Re: Trail Mountain Coal Mine
Sec. 25, T. 17S, R6E.
Emery County, Utah
ACT/015/009

SUBJECT: Trail Mountain Mine (John Bell Mine)
Located in Cottonwood Canyon

SUBJECT: Flood Flows for Design of Cottonwood Creek Crossing
at the Bell Mine

2, 10, & 50 YEAR STORM
HYDROGRAPHS
COTTONWOOD CREEK

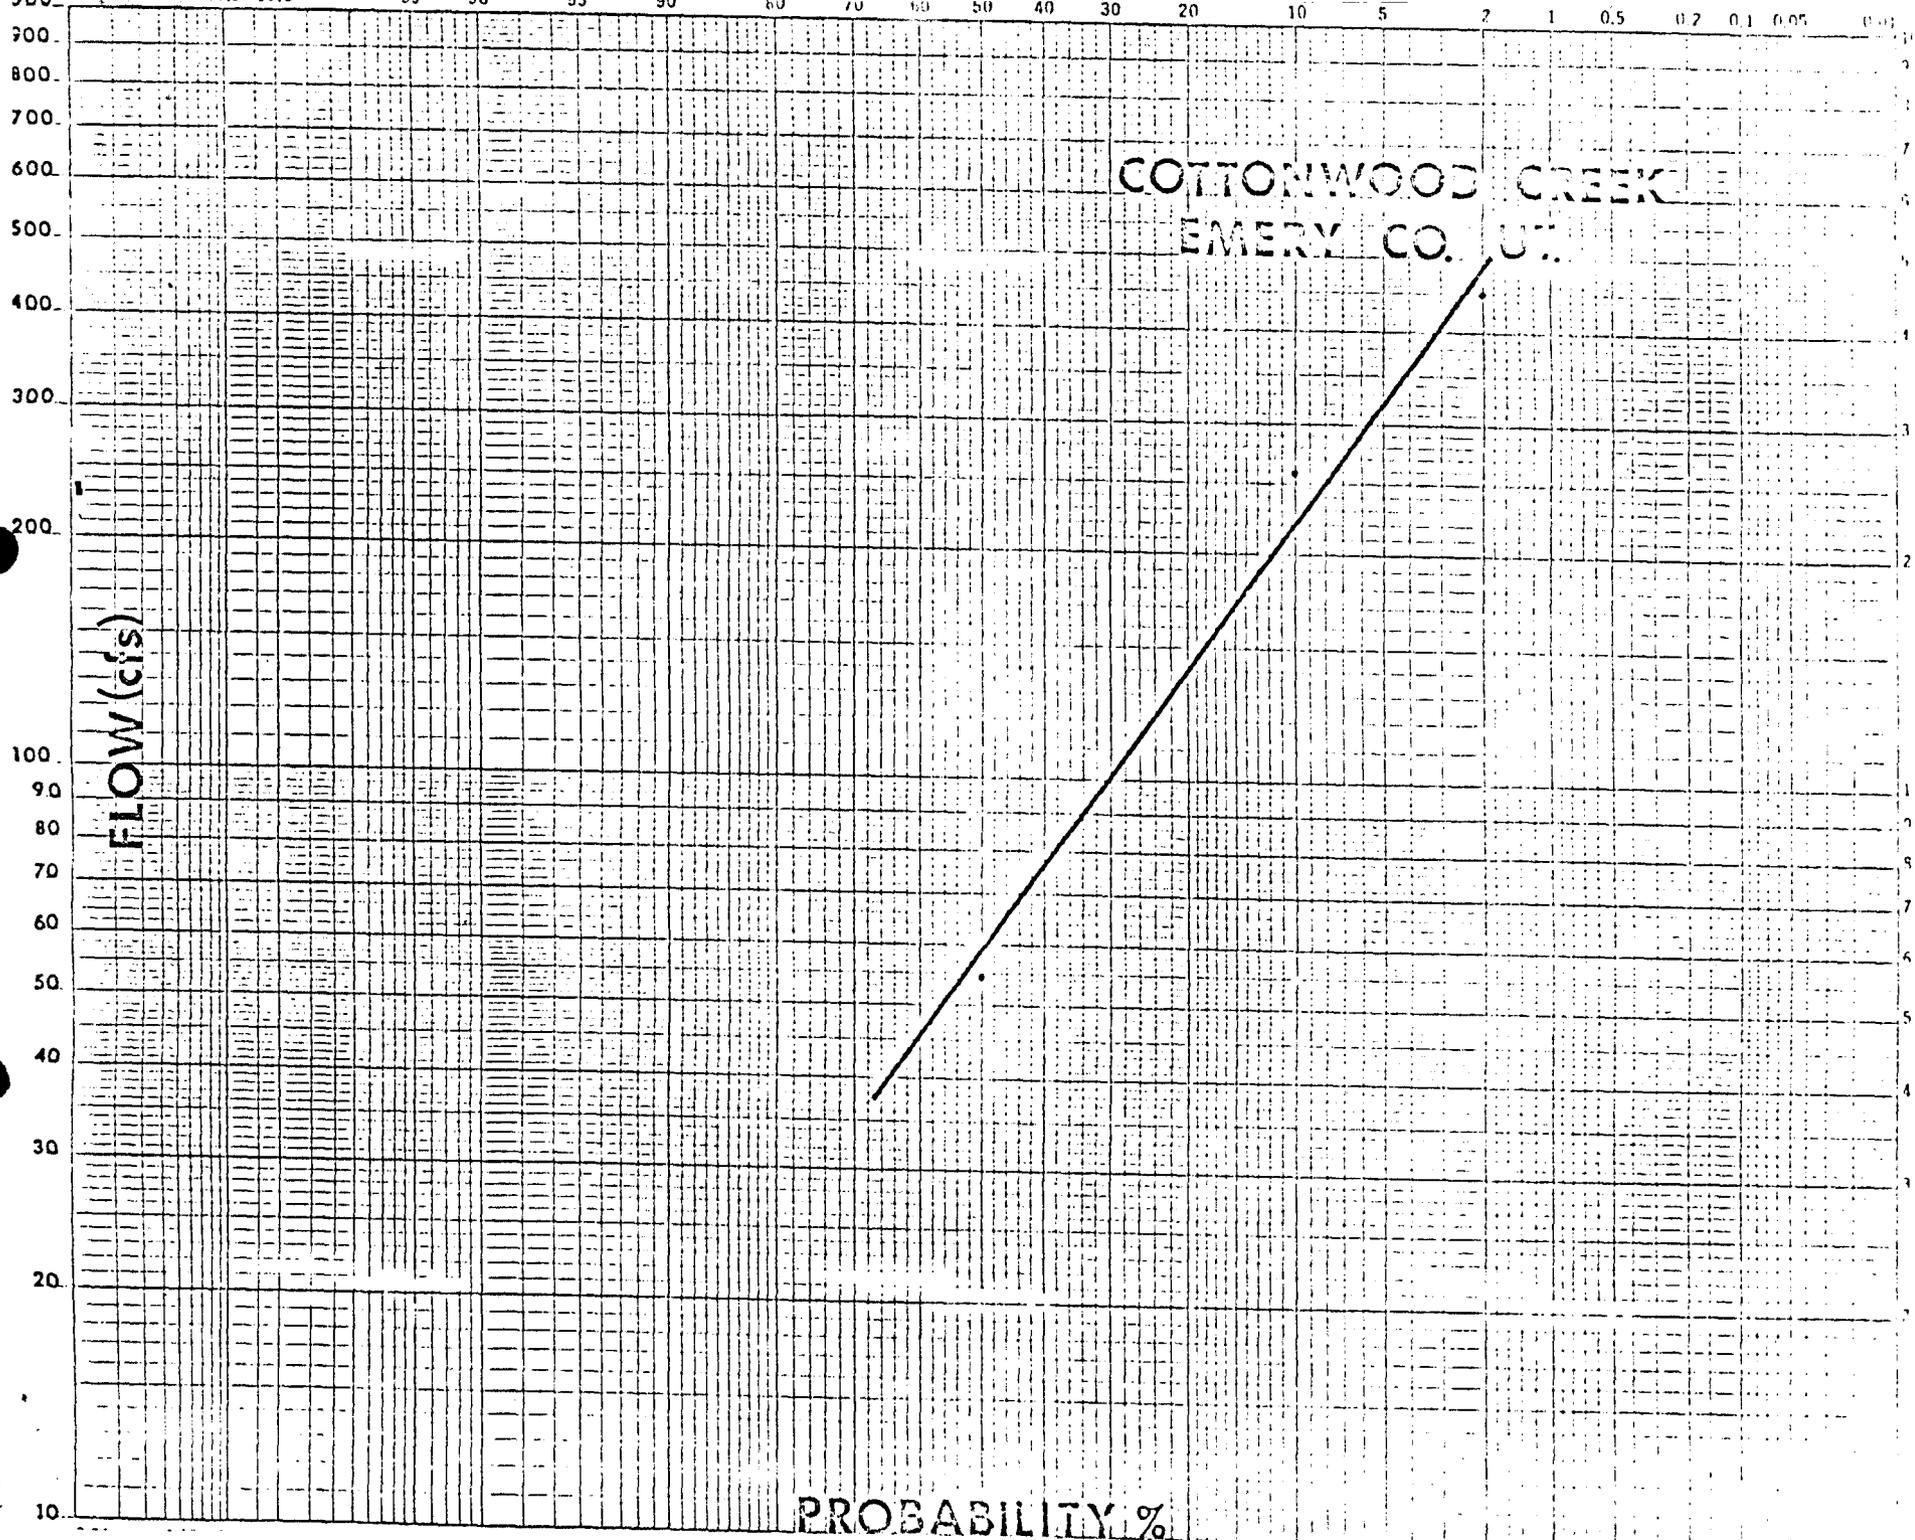
A field survey was performed in 1975 to assess the hydrologic condition of the Cottonwood watershed. The analysis utilized the SCS runoff curve number method to generate runoff hydrographs for 2 year, 10 year, and 50 year storms. The storm synthesized hydrographs accompany this memorandum. The flood peaks from the design hydrographs were plotted on log normal probability paper and the 100 year flood peak was extrapolated by extension of the line through the 2, 10, and 50 year events to the 100 year event.

The analysis showed that the existing culverts are inadequate with respect to Forest Service criteria for passage of flood flows. The two current stream crossings consist of 18 foot fills over 24 inch culverts. The maximum flow that could be passed through such a system with 18 feet of head pressure is approximately 50 cfs. This flow is slightly exceeded by the peak from the 2 year storm. Field observation since the initial investigation suggests that the fill may have been over-topped by water since 1975. Greater magnitude storms may cause a failure of the fill by eroding it. Significant damage to the mine yarding area and downstream resources would result from this cutting. Adequately sized culverts or bridges could alleviate this risk. Table 1 presents the estimated flood peak and the minimum size of culvert required to pass the runoff from large magnitude events.

The flow data mentioned in this document do not provide for the passage of sediment and debris. Significant amounts of both could be generated by extreme runoff events. The rocks, trees, and brush common to the Cottonwood Creek channel have a high displacement probability. It should be kept in mind that this size culvert does not allow for sediment and debris constriction.
